# St Matthews Catholic College, Mudgee

State Significant Development Assessment

SSD 9872

December 2020

**Figure 21 | Proposed road and footpath upgrade works (Base source: Applicant's RtS 2020)**

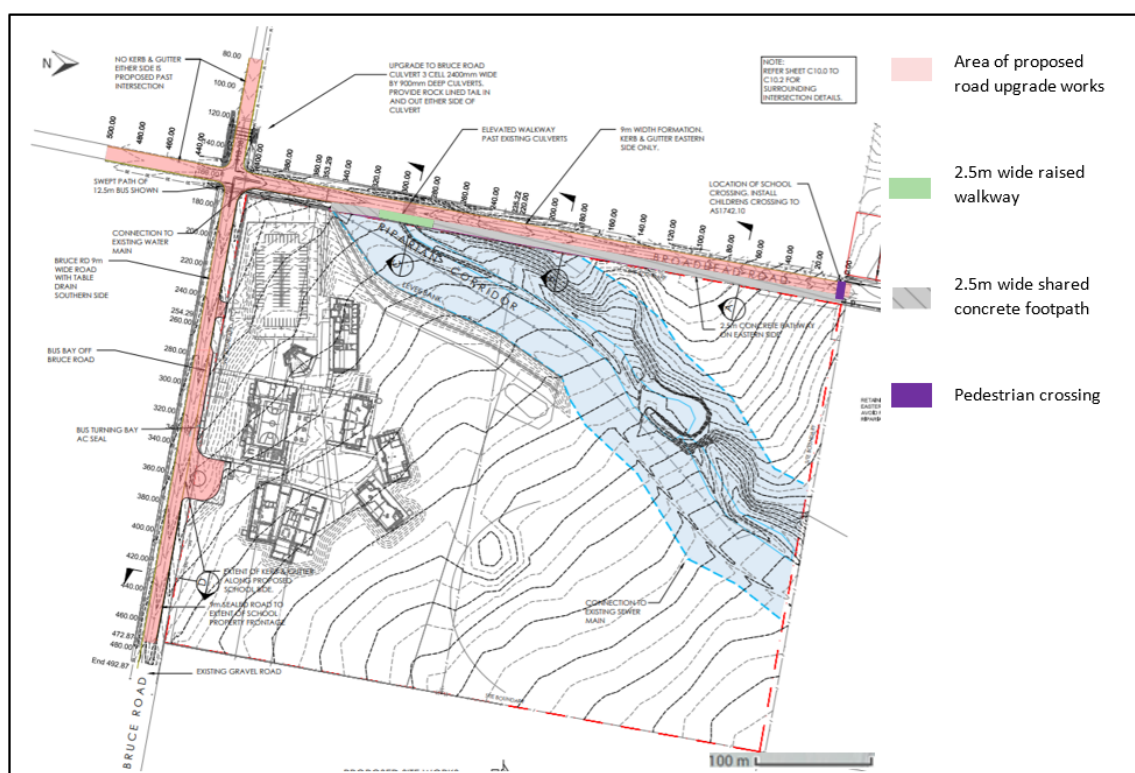
In its submission to the EIS, Council requested changes to the proposed works along Broadhead Road and Bruce Road, including that the proposed footpath on Broadhead Road should extend to Bruce Road. Council confirmed that a pedestrian refuge should be provided to facilitate safe movement from the proposed and existing footpaths on Broadhead Road. It also requested upgrades to three intersections to support bus turning and increased vehicle movements through intersections (shown as 2, 3 and 4 in **Figure 20**) including:

In its response to RtS, Council confirmed that the Applicant's proposed works to the Broadhead Road and Bruce Road were acceptable. However, Council reiterated its request for the upgrade of the three intersections and requested further information from the Applicant to justify that the upgrades were not required to mitigate impacts of the school.

TfNSW advised that the proposed road and footpath upgrade works should be designed to accommodate flood planning (**Section 6.3**) and be completed prior to use of the site. TfNSW also advised that the shared footpath along Broadhead Road should extend beyond the site boundary.

The Applicant's SRtS advised that further discussions were held with Council to negotiate the treatment of the three intersections. The discussions concluded that the Applicant would upgrade two of these intersections for light traffic only (i.e. for parent/carers and staff traffic) and upgrade the third intersection to accommodate school bus movements. The SRtS included concept plans for the proposed upgrades. The SRtS also advised that Council agreed to use the section 7.12 Contributions to be paid by the Applicant (**Section 6.3**) to upgrade Bruce Road to the east of the site that would not be upgraded by the Applicant.

In response to TfNSW's comments, the Applicant did not agree to the extension of the proposed footpath to the end of the site's boundary on Broadhead Road. The Applicant advised that this encourages pedestrian access onto Bruce Road which has no footpath infrastructure and would cause conflict between pedestrians and drivers.

**Figure 22 | Drop-off / pick-up area arrangement (Base source: Applicant's RtS 2020)**

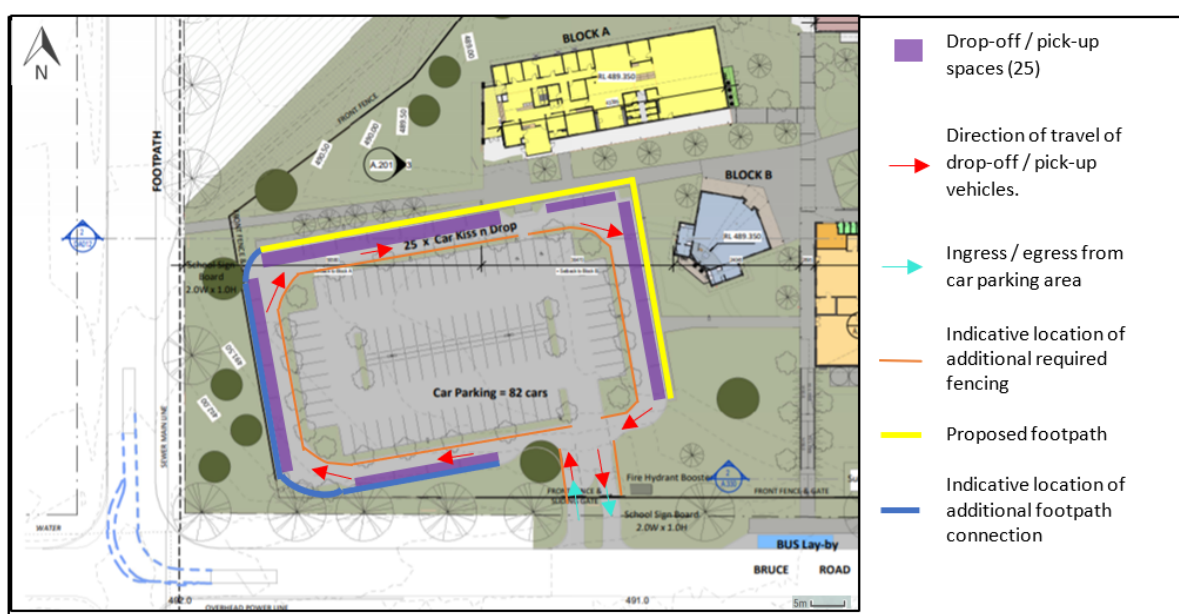
TfNSW advised that the design of the proposed entrance / exit arrangements would result in confusion to drivers, traffic congestion and safety issues.

In its response to RtS, Council and TfNSW requested that pavement marking and signage be incorporated to separate users of the drop-off / pick-up zone and the car parking area, to minimise confusion. TfNSW also recommended that a fence be installed along the perimeter of the carpark, to separate students using the footpath from the drop-off / pick-up area.

The RtS included a revised design (**Figure 22**) that increased the number of drop-off / pick-up spaces to 25 and introduced a shared entrance / exit for both the drop-off / pick-up area and car park.

The Department has considered Council and TfNSW advice and the information provided by the Applicant. The Department is satisfied that the revised layout provides simpler access arrangements into the drop-off / pick-up area and car park. The Department agrees with TfNSW that appropriate line

**Figure 23 | Bus parking and swept path analysis (Base source: Applicant's RtS 2020)**

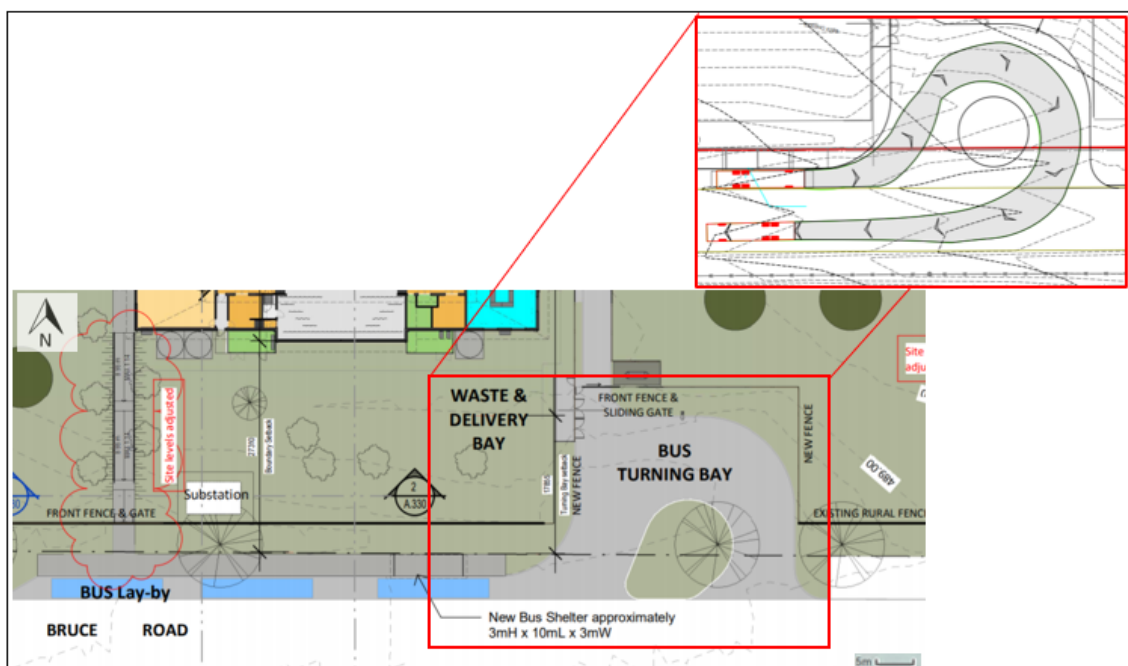
In response to the EIS, Council requested further information to show that buses could safely exit via a right turn onto Bruce Road with the additional traffic expected during school pick-up / drop-off times. A swept path analysis was required to demonstrate that buses travelling south on Broadhead Road could appropriately conduct a left turn onto Bruce Road. Council also requested weather protection be provided for students waiting for buses.

Council made no further comments in response to Applicant's RtS. TfNSW requested that one additional space be provided to avoid bus queuing on roads. TfNSW recommended the redesign of the bus bays be prepared in consultation with Council and TfNSW, prior to the commencement of works.

Additional swept path analyses were provided with the RtS and the Applicant advised that it was expected there would gaps in traffic along Bruce Road to enable buses to safely exit the site. Amended plans were submitted as part of the RtS showing a bus shelter for students.

In response to the above comments, the Applicant confirmed that the number of bus bays had been determined in consultation with the bus operator and would be sufficient.

**Figure 29 | Flood and stormwater mitigation works (Base source: Applicant's RtS 2020)**

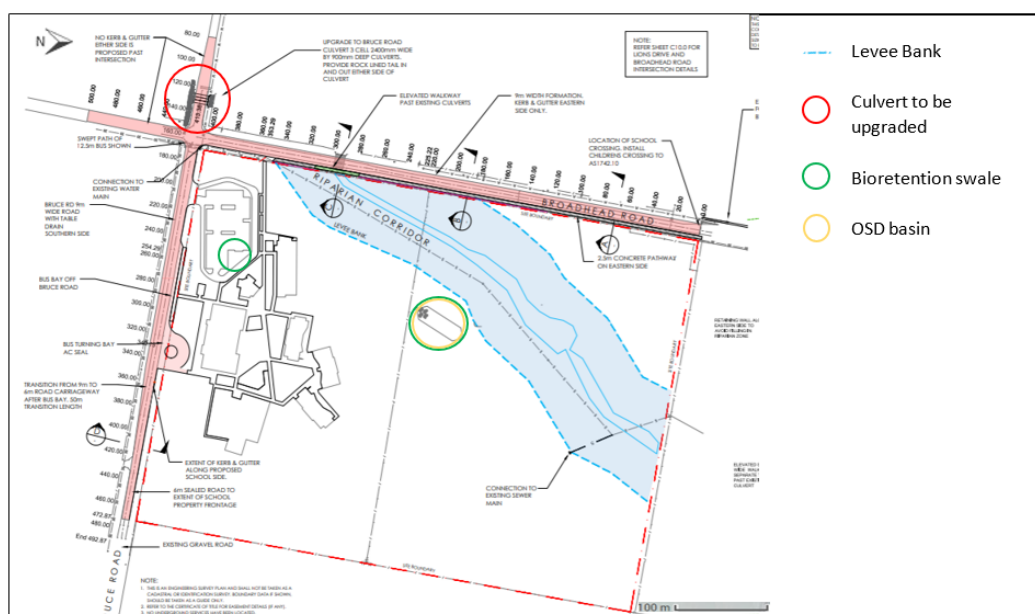
The Department and Council requested the Applicant provide a detailed Stormwater Drainage and Management Plan.

graded landscaped earthen mound 500 millimetres high and landscape bund along Bruce Road to divert upstream water around the school buildings. The report also recommended that all buildings incorporate 150 millimetre freeboard to mitigate flooding impacts in the event of a 1:100 year storm event. The report concluded that there would be minimal impacts on surrounding properties due to the proposed development. The Applicant's RtS included amended plans that incorporated the change.

The RtS confirmed a portion of the Broadhead Road footpath would be raised over the existing culvert below the road. This is consistent with recommended stormwater and flood mitigation strategies and would ensure the safety of pedestrians accessing the site via Broadhead Road.
